SUNDRY NOTICES AND REPORTS ON WELLS (DO NOT USE THIS FORM FOR PROPOSALS TO DRILL OR TO DEEPEN OR PLUG BACK TO A DIFFERENT RESERVOIR. USE "APPLICATION FOR PERMIT" (FORM C-101) FOR SUCH PROPOSALS.)		WELL API NO. <b>30-025-29201</b>

2. Name of Operator <b>Mack Energy Corporation</b>		6. State Oil & Gas Lease No. <b>V-1420</b>
3. Address of Operator <b>P.O. Box 960 Artesia, NM 88210</b>		7. Lease Name or Unit Agreement Name <b>Silver State</b>

Mack Energy Corporation		CURRENT	
Author:	Abby @ BCM	Well No.	#1
Well Name	Silver State	API #:	30-025-29201
Field/Pool	Arkansas Junction; SA	Location:	Sec 13, T18S, R36E
County	Lea		330 FNL & 1980 FWL
State	New Mexico	GL:	3775.59
Spud Date	3/31/1985

Mack Energy Corporation		PROPOSED	
Author:	Abby @ BCM	Well No.	#1
Well Name	Silver State	API #:	30-025-29201
Field/Pool	Arkansas Junction; SA	Location:	Sec 13, T18S, R36E
County	Lea		330 FNL & 1980 FWL
State	New Mexico	GL:	3775.59
Spud Date	3/31/1985

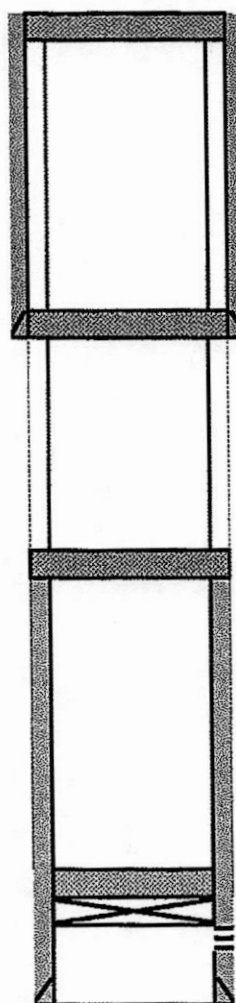
Note changes to procedure

Spot 25 sx Class C 3376 7 Rivers

Spot 25 sx Class C 3994 Queen
